# Newmar Corporation Warranty Department

Technical Service Bulletin							
Date Issued	Model	Year(s) Affected		Model(s) Affected			TSB#
7/13/09	7/13/09 2009-present Diesel			Diesel Pu	sher/Bus		362
	В	rand				Type	
All Star Bay St	ar 🗆	Canyon Star 🗖	Grand	Star	All 🗖	ТТП	FW □
Ventana <b>I</b> Dutch	Star	Dutch Aire	Mour	ntain Aire	САП	D₽■	DB
Essex <b>I</b> King	Aire	London Aire 🗖					
□ Air Conditioning & Heating □ Electrical Components □ Appliances & Accessories □ Exterior Components □ Cabinets & Furniture □ Interior Components □ Chassis Components □ Plumbing & Bath Components □ Construction Components □ Windows, Awnings, Vents, & Doors □ Description of Problem  Certain quick release valves manufactured by Haldex and distributed by Meritor Wabco to Spartan Chassis, Inc. contain a rubber diaphragm that may delaminate and cause air leakage that exceed permissible specifications or could cause a restriction or blocking of the air flow, thereby affecting pressure delivery and release to the foundation brakes.

# RECALL SERVICE BULLETIN

**SUBJECT:** Brake System – Haldex QR1 & QR1C Valves

QR1C VALVE FIG. 3-1

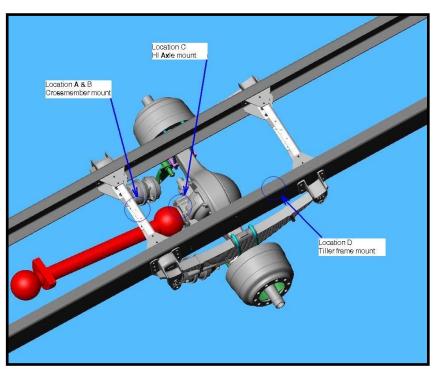
NOTE: Refer to FIG. 3-1, 3-2, 3-3. Some Firetruck Cab/Chassis may be equipped with 1 (one) QR1 and/or 1 (one) QR1C valve. Valve mounting location may vary, from front crossmember near transmission for QR1 Valve to Rear Axle for QR1C Valve and in certain cases both locations.

- 2. Refer to Haldex Bulletin Pgs. 4-6. Locate and Inspect quick release valve(s) to identify date code. If valve date code is in the specified range of May 27, 2008 through October 15, 2008, with production date codes of 148 through 289. The QR1 & QR1C valve(s) will need to be replaced.
- 3. Disconnect brake drop hoses and/or air lines from quick release valve(s).
- 4. Loosen and remove quick release valve(s) from relay valve assembly or crossmember. Retaining mounting hardware for reuse.

Recommended Solution  Follow instructions to locate, identify and replace valve if its date code is in the range as listed by the Spartan Chassis documentation attached.
